# UNITED STATES PATENT AND TRADEMARK OFFICE

APPLICATION NO.	FILING DATE	FIRST NAMED INVENTOR	ATTORNEY DOCKET NO.	CONFIRMATION NO.
10/578,330	03/05/2007	Sten Wallsten	10400-000229/US	5702
36593 7590 12/22/2008 HARNESS, DICKEY & PIERCE, P.L.C. P.O. BOX 8910 RESTON, VA 20195				
EXAMINER SEVERSON, JEREMY R				
ART UNIT		PAPER NUMBER		
3653				
MAIL DATE		DELIVERY MODE		
12/22/2008		PAPER

# Office Action Summary

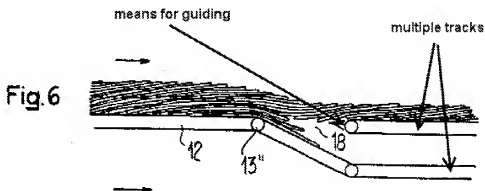
Regarding claims 1 and 2, Dietrich discloses a method of storing printed products in one or more layers, the method comprising: storing the printed products on at least one substantially circular conveyor track (19); supplying the printed products (from stack S) to the conveyor track at least at one point in the track and discharging the lowermost layer from the conveyor track through an opening in the track (18); the supplying and discharging of products being independent of each other, wherein printed products are supplied to the track while at the same time printed products are discharged from the track at the opening.
